ADDENDUM NO. 04 (MEPT)

Date of Issuance: April, 23, 2026

Project: **Replacement Elementary on Mustang Rd.**
Alvin Independent School District

Texas Arcadis Inc.
Project No.: 202502 - 30268973

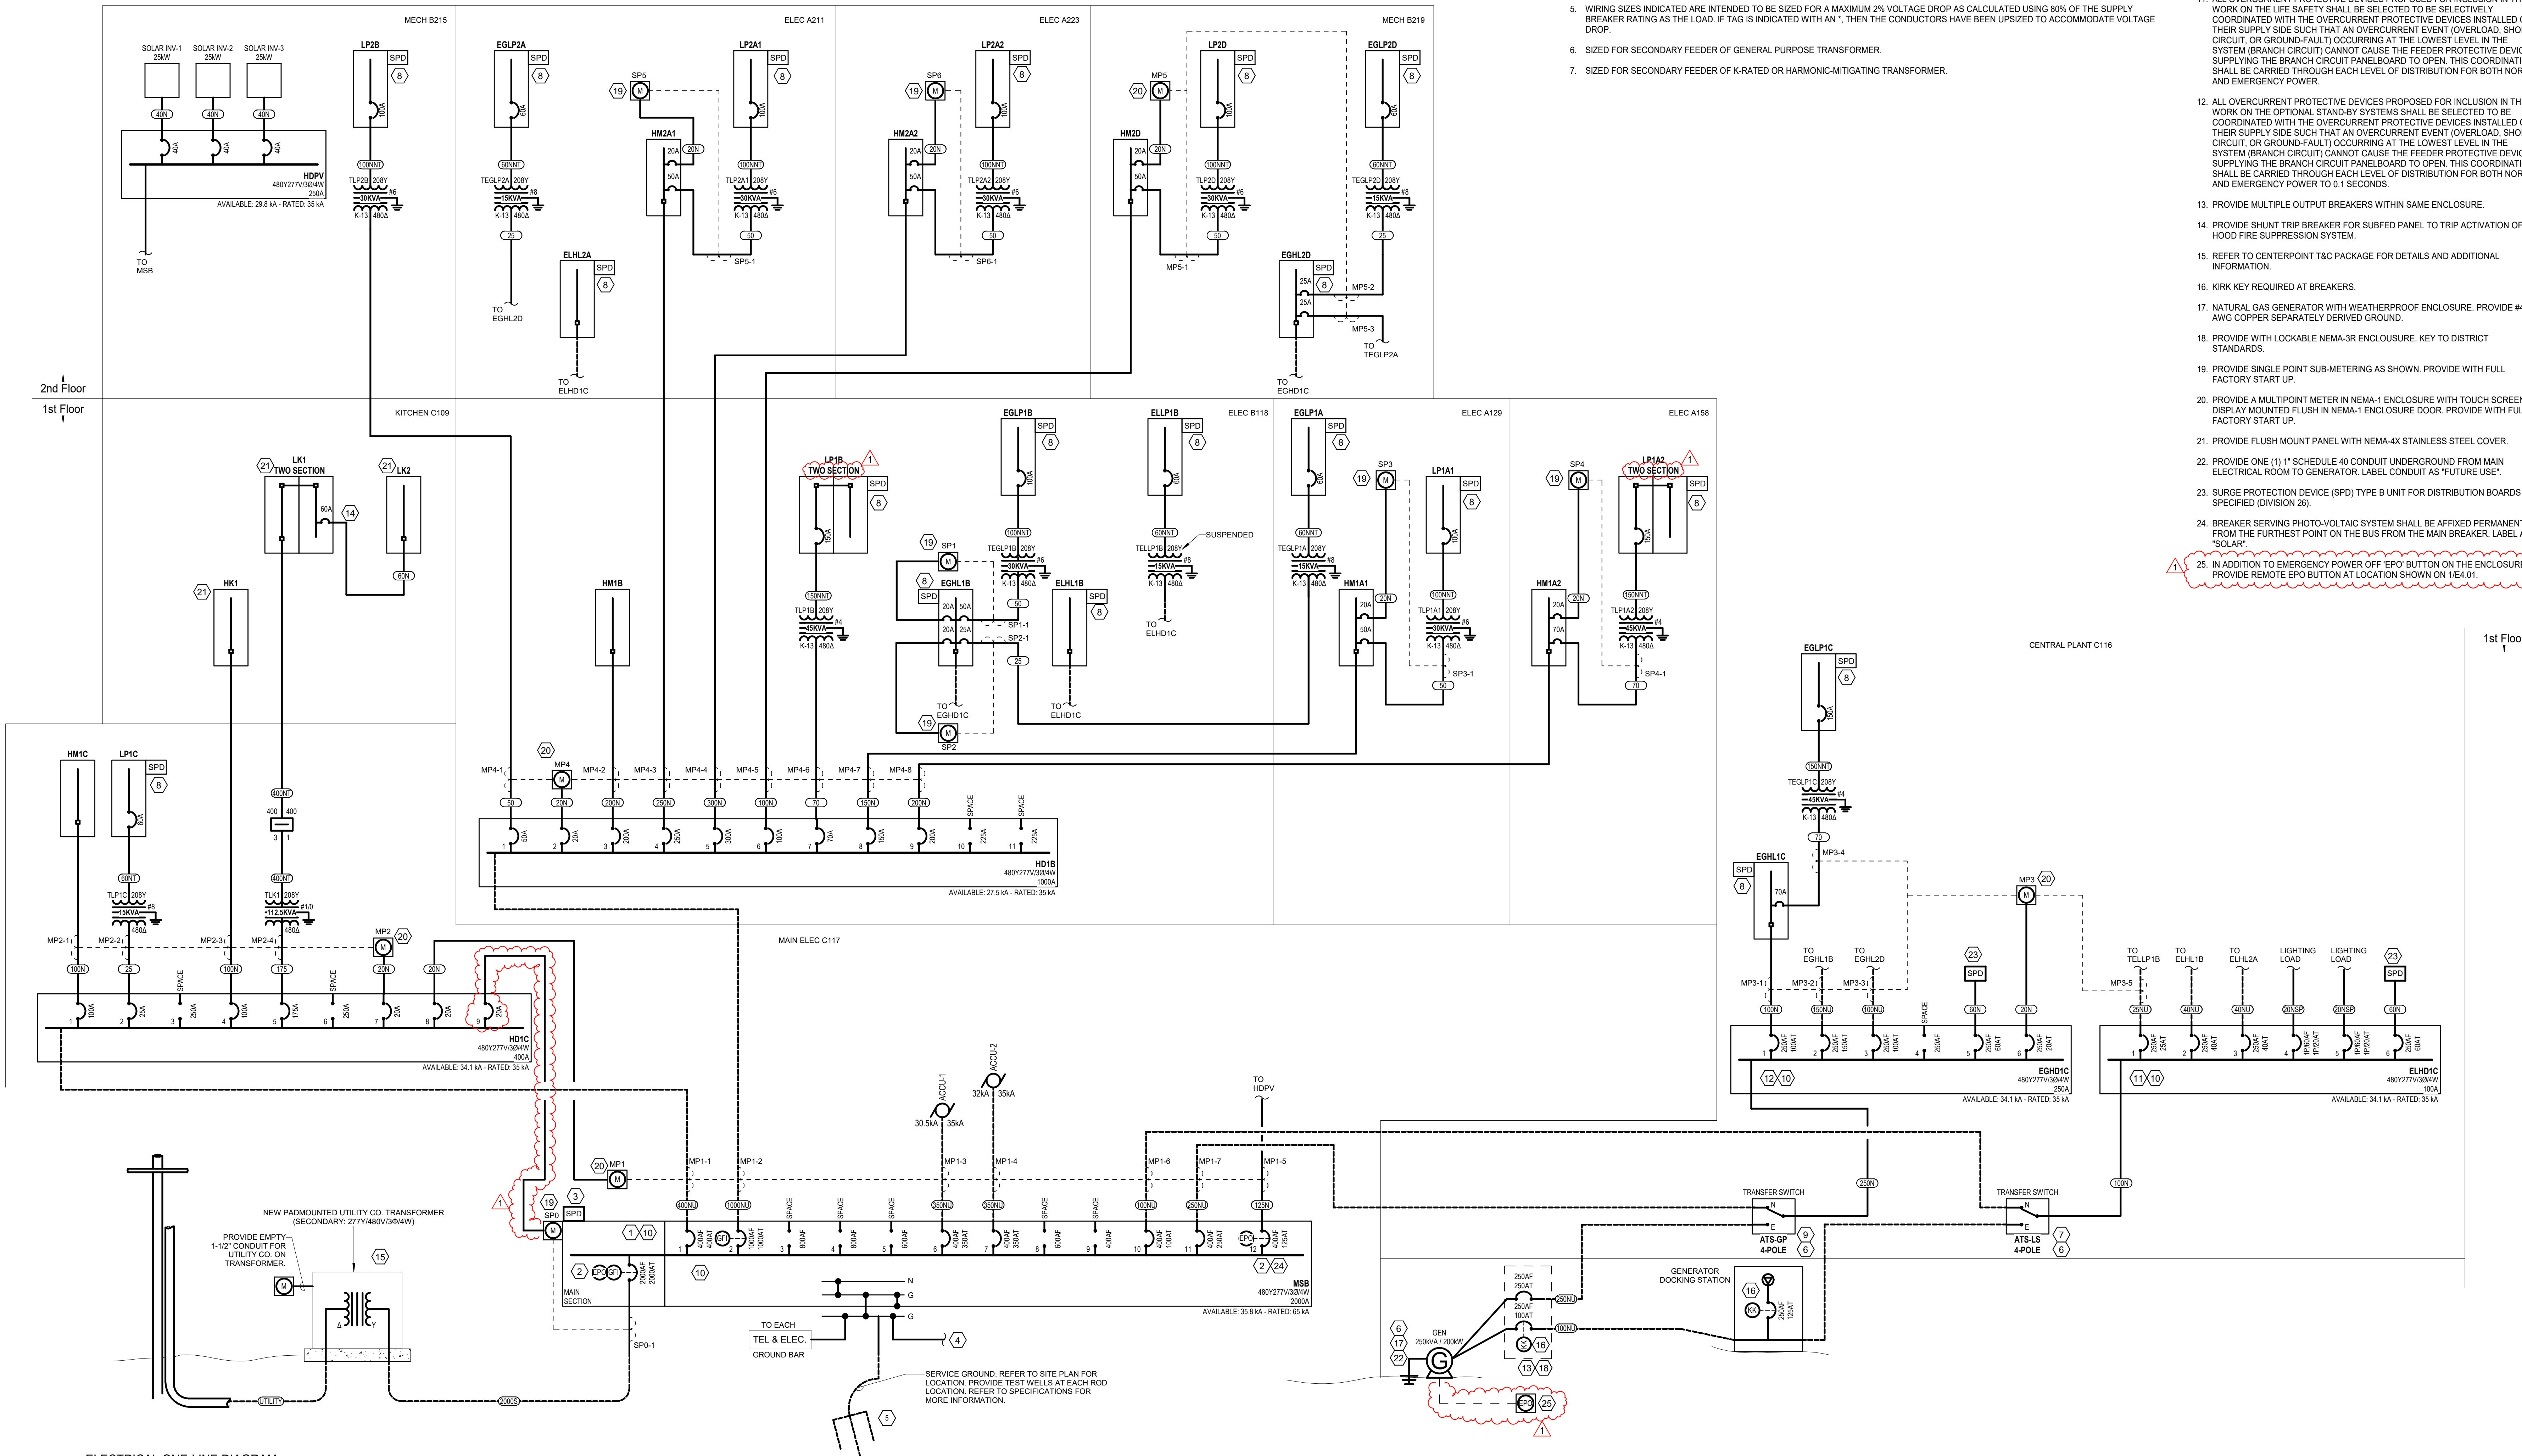
- 56. Sheet E5.01 – ELECTRICAL ONE-LINE DIAGRAM
 - a. Added remote EPO button to generator.
 - b. Provide 20A/3-pole breaker at HD1C to power Meter SP0 serving MSB. Refer to sheet.

- c. Clarification: Panels LP1A2 & LP1B shall be two section.
- 57. Sheet E7.01 – LIGHTING SCHEDULES
 - a. Lumen package for Columbia model for type F450 and FW450 modified as shown.
